**MODIFICATION REQUEST
Former Sunbeam Factory
60 Charlotte Street Campsie
MP07_0106 & MP08_0087 MOD 1**

Director-General's
Environmental Assessment Report
Section 75W of the
Environmental Planning and Assessment Act 1979

December 2011

Figure 3: Residential Display Suite and location of Stage 1 Residential Building

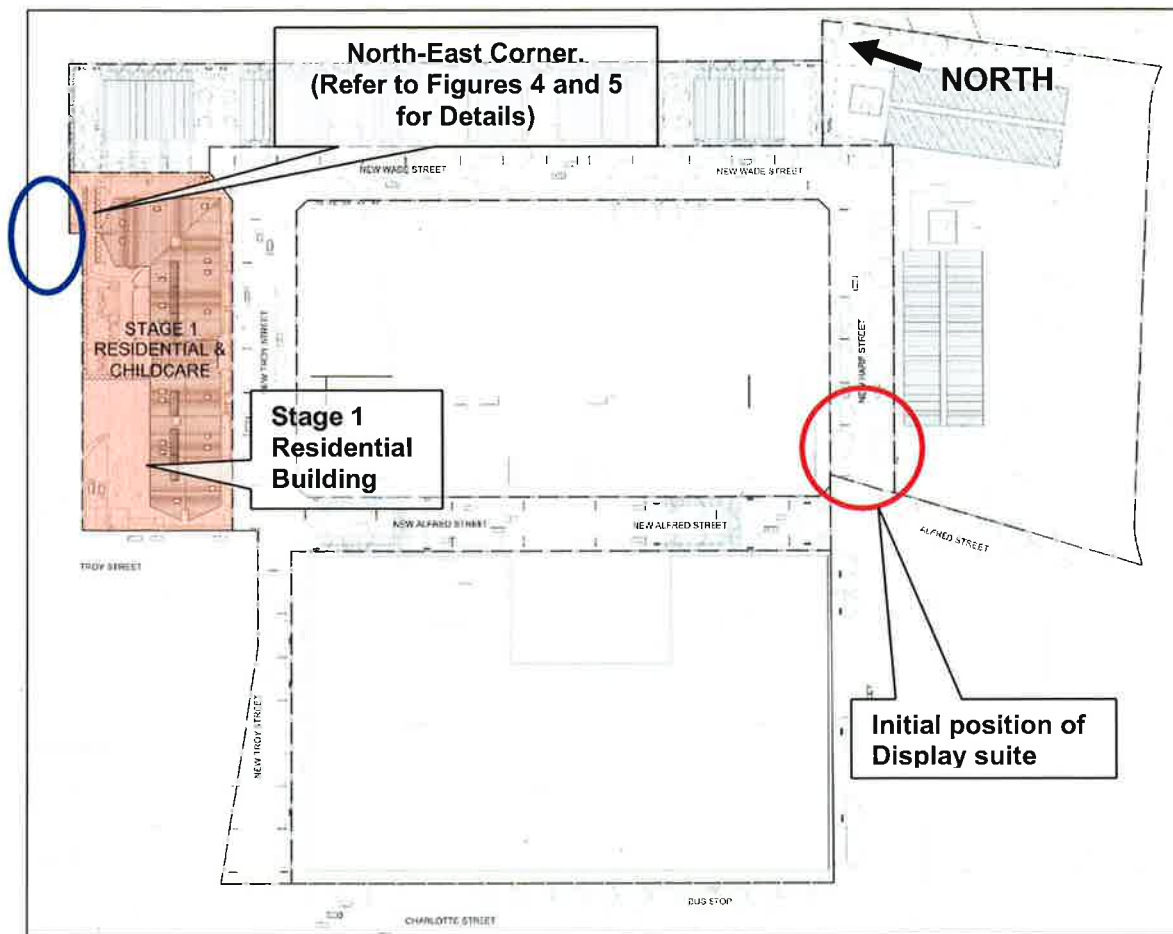
The Proponent has indicated that the display suite will be initially located on the southern section of the site on the corner of Alfred Street and the proposed extension to Harper Street (**Figure 3**). The submitted plans indicate that the display area will be made up of 803m² including a display suite (approximately 230.4m²), associated landscaping and the provision of 8 parking spaces. The proposed suite is to be a single storey building with access from Alfred Street.

The Proponent has stated that over the construction period, it would be required to relocate the display suite and that provision be made within the Concept Plan for this relocation without the need for further approval.

The Department considers that a display suite is necessary to market the redevelopment, and given its temporary nature, the display suite will not alter the intent of the Concept Plan. However, further details of the display suite will be required to form part of separate applications to Council under Part 4 of the Act including subsequent relocation of the display suite.

Figure 4: Proposed Stage 1 Setbacks

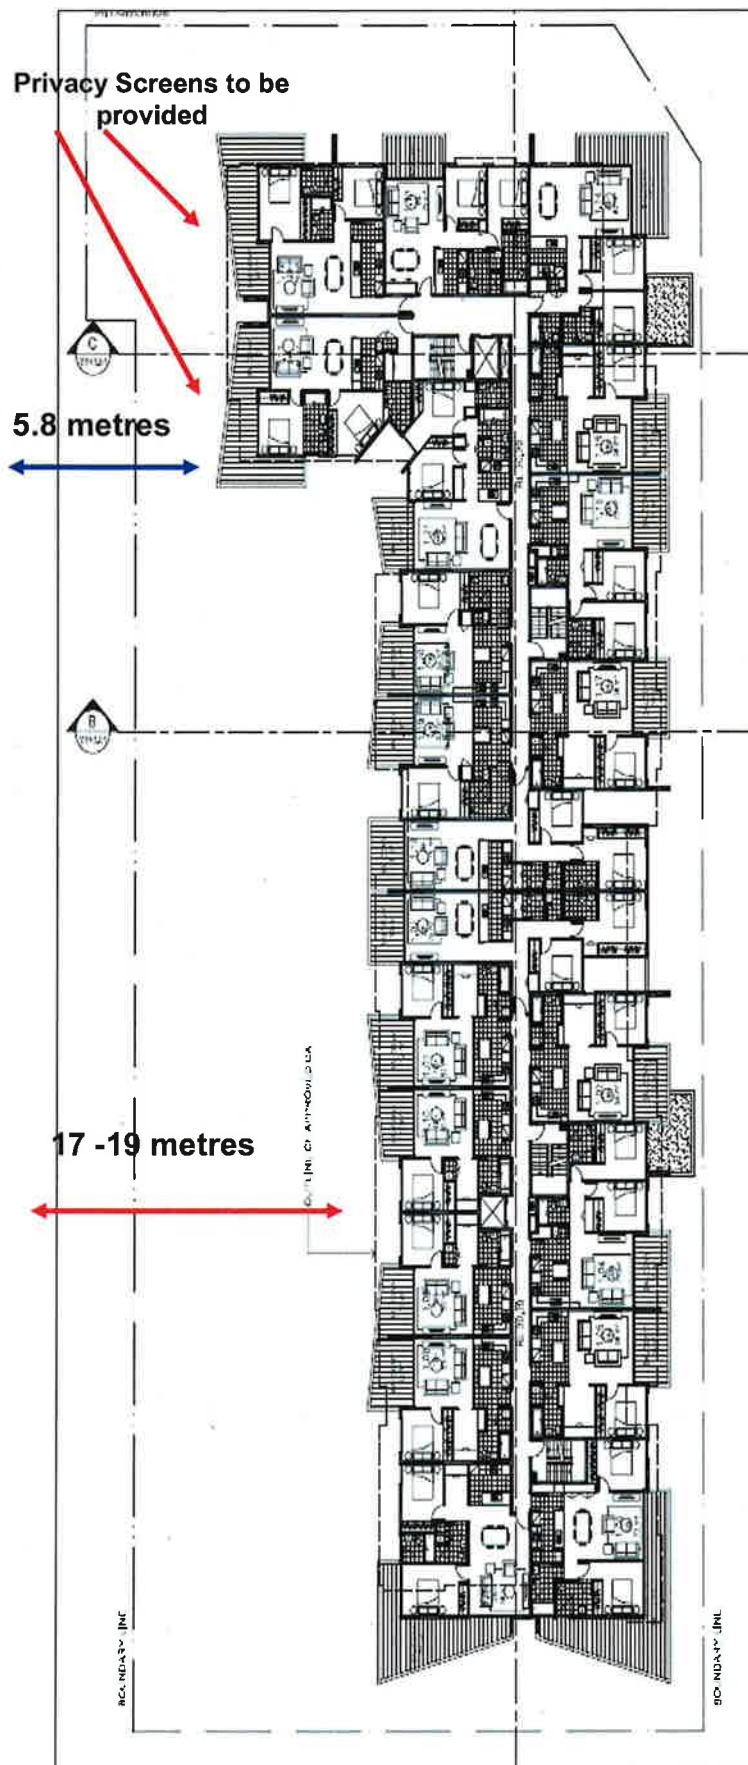
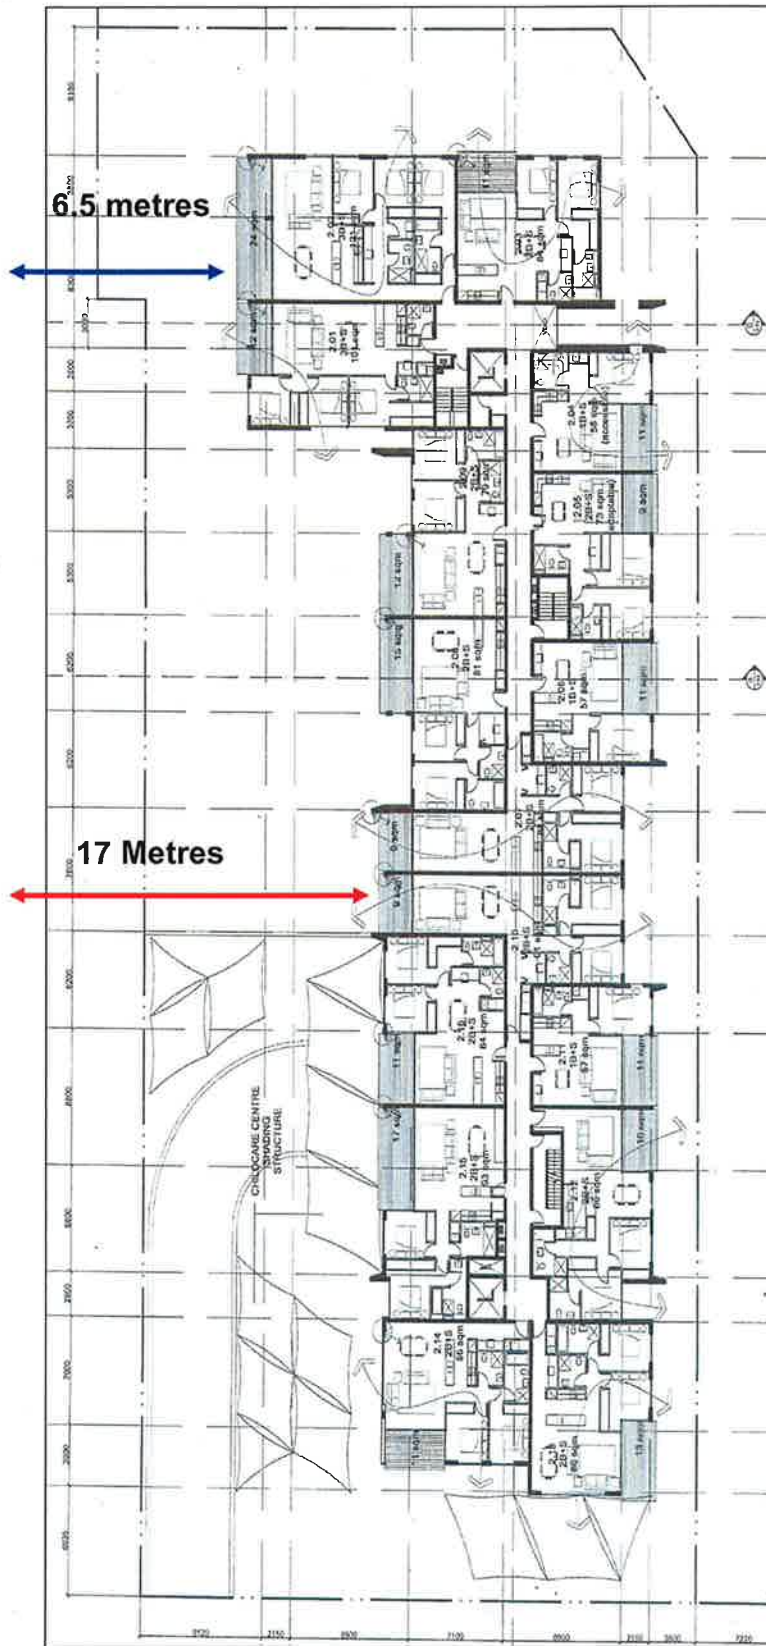
The setback of the balconies from the boundary at the north-east corner will be reduced from approximately 6.5 metres to approximately 5.8 metres. As illustrated by **Figures 4 and 5**, the reduced separation sought in the modified layout will impact upon the privacy of neighbouring

residential properties. The Department therefore considers it necessary to retain the louvers (as required by Condition B34 of the approval) on this part of the building and only for levels 1 to 3. The Department considers the proposed landscaping and boundary fencing is adequate to prevent direct overlooking at ground level. The condition will be amended as follows:

*'Fixed upward facing louvers must be attached to the top of the balustrade of all of the balconies on the northern **north-east corner** elevation of the building **for levels 1- 3 (6 units)** on proposed Lot 11. The louvers must extend to the underside of the ceiling of the balcony, and must be sliding to cover a minimum 50% of the width of each balcony of the building to protect neighbours' privacy'*

Figure 7: Proposed Location of Substation

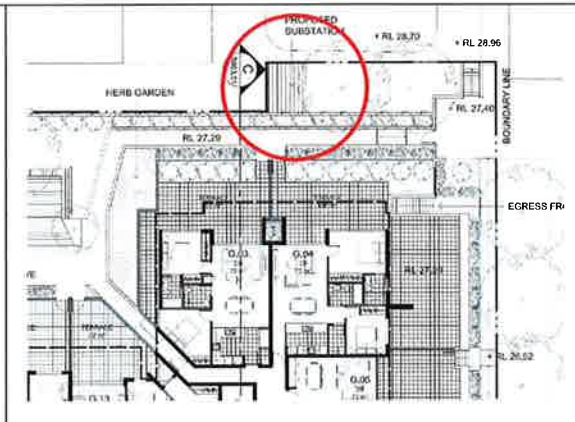
The approved substation measured approximately 3 x 6 metres and was located in the north-east corner of the Stage 1 site at the southern end of Wade Street. The modification includes reducing the size of the substation to approximately 3 x 3 metres and moving it approximately 3 metres to the west. Access to the substation will remain from Wade Street and the reduced size will allow for additional landscaping thereby reducing its visual impact upon the locality (**Figures 6 and 7** illustrate the repositioned Substation).

The Department considers the changes to the landscaping to be minor as they will not result in any significant change to the nature of the scheme as approved. The inclusion of the sound mitigation wall and the relocated substation will also improve the layout and appearance of the landscaped area.
